PANEL REFERENCE & DA NUMBER	PPSHCC-147- MA2022/00286 (DA2019/00711) File Number 2019/39309 EXP No 1 National Park Street Pty Ltd v Newcastle City Council
LGA	City of Newcastle (CN)
PROPOSED DEVELOPMENT	Section 4.56 Modification to a Development Application for a mixed used development comprising demolition, retail, commercial, public spaces, residential apartments, associated parking, staging, and stratum subdivision.
STREET ADDRESS AND OWNER DETAILS	Lot 1171 in DP 858465; Lot 1181 in DP 596950; Lot 99 DP 1134475; Lot 1 in DP 741514; and Lot 100 in DP 612505. 1, 17, 19 National Park Street and 434 King Street Newcastle West
APPLICANT	GWH BUILD DEVELOPMENTS PTY LTD
OWNER	EXP NO 1 National Park Street Pty Ltd
DATE OF DA LODGEMENT	26 August 2022
ORIGINAL DA DETERMINATION DATE	21 September 2020 Jurisdiction: Class 1 File Number 2019/393097
APPLICATION TYPE	Modification Application under 4.56
REGIONALLY SIGNIFICANT CRITERIA	Clause 2, Schedule 6 of <i>State Environmental Planning Policy (Planning Systems) 2021</i> : General development with a CIV greater than \$30 million. Section 275 of the <i>Environmental Planning and Assessment Regulation 2021</i> states that a council must not deter

Figure 1: – Height Plane Diagram 60Figure 2: – Height Plane Diagram 66mFigure 3: Southern Tower Approved HeightFigure 4: Northern and Southern Tower Approved HeightFigure 5: Proposed Northern and Southern Tower Height

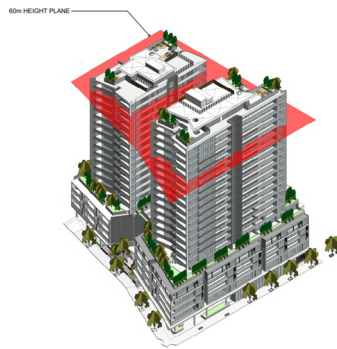
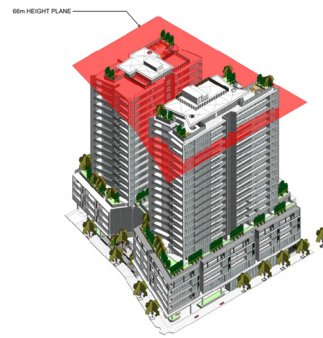
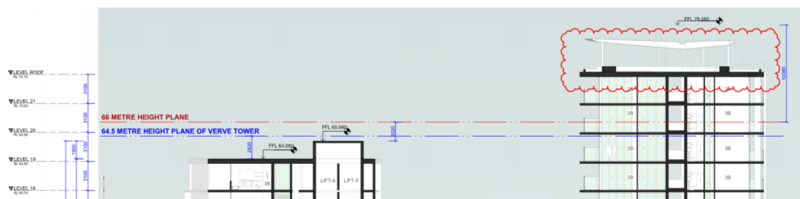
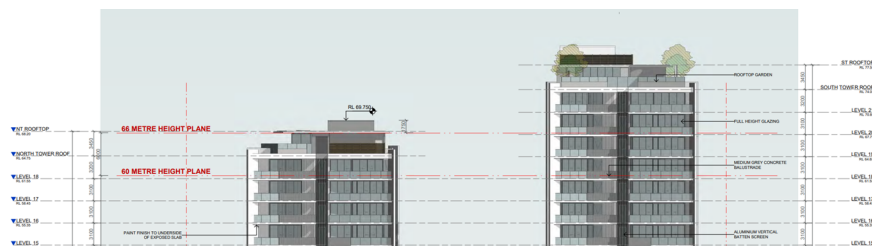
The above table provides a clear breakdown of height exceedance that applies to the rooftop elements including lift overrun and architectural roof features.

The overall building height has increased to incorporate the lift overrun and rooftop communal open space areas (now located on both towers). The development as approved did not include a rooftop communal area on the northern tower. It is noted that the approved rooftop design on the southern tower presented as a slender form, which has now become slightly flatter with the removal of 'winged roof'.

The height exceedance will not result in any detrimental impact on the adjoining properties or the public domain. The proposed rooftop communal space does not adversely impact on privacy, solar access, or views. A significant extent of the proposed variation to the height relates to the provision of a communal rooftop areas for future residents. This inclusion ensures that the future occupants of the development are provided with a high level of amenity that will not impact on any surrounding view corridors.

Figure 7: Proposed National Park Street elevation.

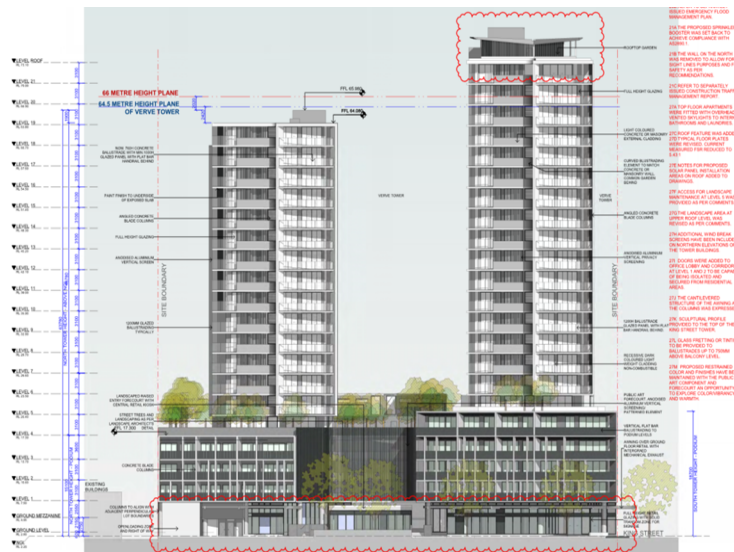
Whilst exceeding the building height standard for the site, the proposed development contributes to the locality through an active streetscape with commercial tenancies on the ground floor, and a slim tower design. The development is compliant with the prescribed floor space ratio development standard, which has ensured that the overall massing of the podium and towers remains unchanged.

Should the proposal be required to strictly comply with the prescribed height requirement, the bulk and scale would appear as a large mass when viewed from the public domain. Ensuring that the approach to height is scaled, the visual impacts are reduced on the public domain and the west end precinct.

Council is satisfied that the documentation has adequately addressed the variation to the height limit and the proposal can be supported. The proposal continues to achieve the objectives of both the prescribed zone and building height development standard. The proposal amended development will not result in an unreasonable impact on amenity or result in any significant adverse environmental impacts as a result of the variations.

Mark-up of Ground Floor Commercial Parking to accommodate End User facility and bicycle parking.

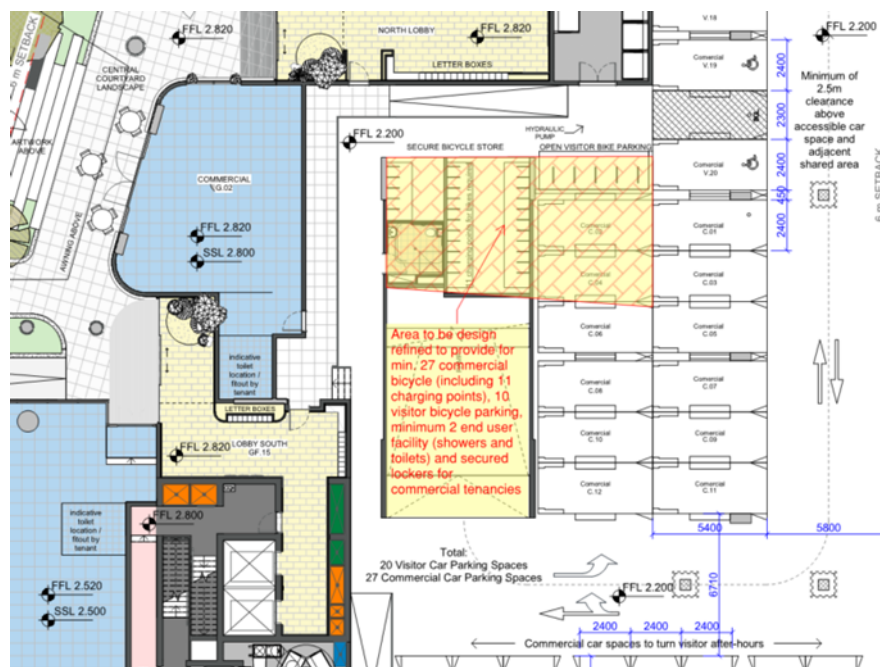
The removal of two (2) commercial parking spaces and redesign of the proposed area to allow for additional showers, toilets, change rooms, lockers alongside bicycle parking will allow for cyclists to use the area at one central location.

The current proposal is for use of the commercial unit toilet facilities as change and shower rooms, it is hard to comment on how this can practically be managed in an office environment.

Extract 3 – Street tree planting concept

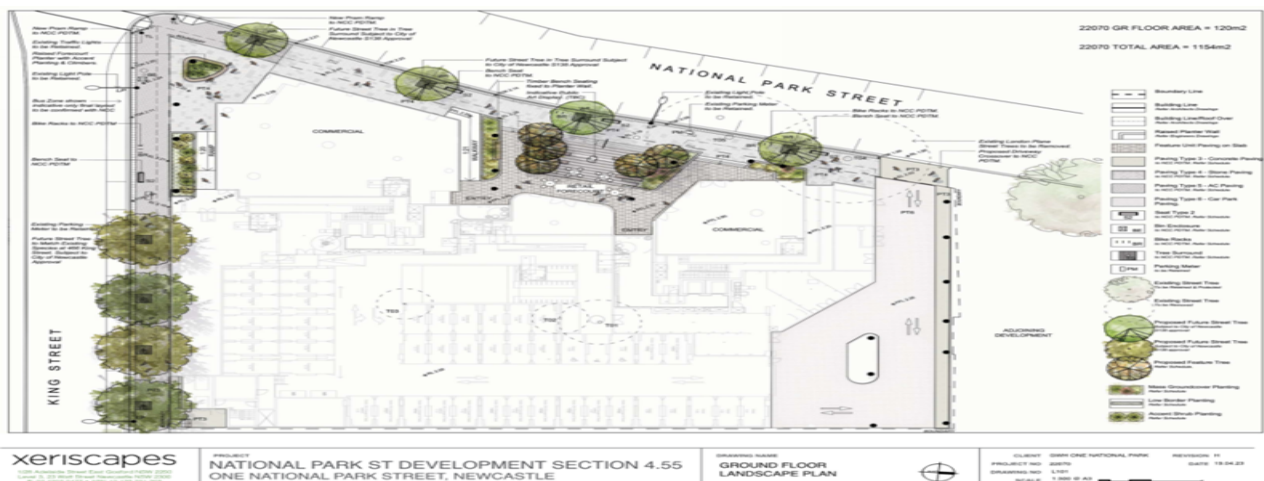
Consultation has been done with CN City Greening team and a concept proposal for street tree planting on King St and replacement of the removed tree has been provided (See Extract 3 below). This information has been relayed to the applicants and no objections have been raised.

Figure 4 – End of Trip Facilities

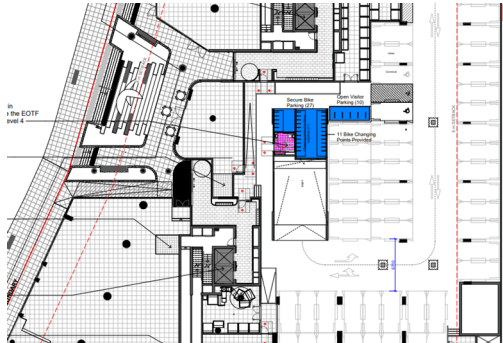
Inclusion of common end of trip facilities have been included in the proposal. Something about non-compliance with the DCP. As the proposal seeks an additional 32 car parking spaces, CN considers that the proposal should accommodate addition end of trip facilities as identified on the plans. This

has been further conditioned and will require details to be provided, prior to the release of the construction certificate. CN does not consider that the EOT facilities should be located within the individual tenancies or within the communal podium area that is dedicated to residents.

Figure 6: Materiality – Tower Winter Garden

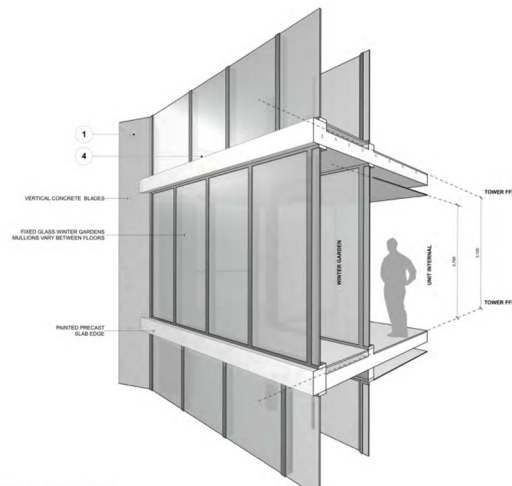
The applicant was requested to confirm the finished floor levels of the balcony and the internal living area of the units. After review of the drawing no. 'S455-A3-025' there was a concern that the slab design would result in a 'step-up' from the internal area to the balcony / winter garden.

The applicant did not want to provide the details of the FFL and stated that they were provided on the submitted floor plan. It was explained that they could talk to the HCCRPP as to why this detailed should not be provided as part of the assessment.

"See attached typical balcony detail showing the internal and external floor heights. All our Balconies are typically 20mm porcelain pavers on adjustable proprietary pedestal system. The FFLs (Finished Floor Levels) are typically 50mm higher at the balcony from the internal apartment FFL, with a step over hob/ subsill detail to ensure Balcony sliding doors weather proofness and freeboard as required to comply with NCC and AS4654".

Figure 7: Common Open Space Area

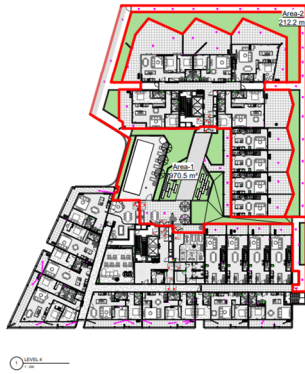
The amended plans included the calculation of the landscaping space of private units as shown below. CN requested that the applicant amend the plans to exclude the balconies and landscaping of the private units.

The inclusion of this space as a standalone communal open space area was not accepted by CN. Area 1 is primarily made up of steps to the development, is not located a level area, and does not have a minimum dimension of 3mtrs. Arguably, the images noted under Section 3D provide clear examples of what is considered as communal and public open space.

The applicant subsequently responded by removing the nominated Area 2 to included Area 1 being the entrance the proposed building. The applicant detailed that Area 1 had been excluded from the calculations being the entrance forecourt to the proposal.
